TMY NEWS / NO. 1165 / MICRO

Notice of design change

MICRO No. MAR-94 (A-94)

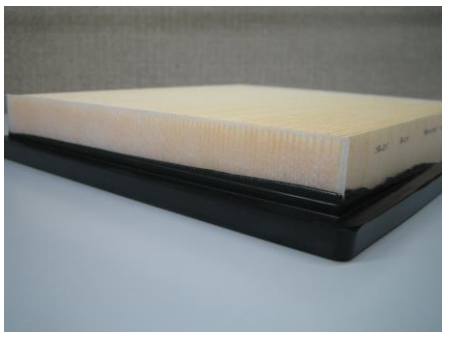
It's changed to the shape same as a genuine products.
Removal of an end plate. Application of hotmelt glue to the filter part both sides and a filter paper central part.
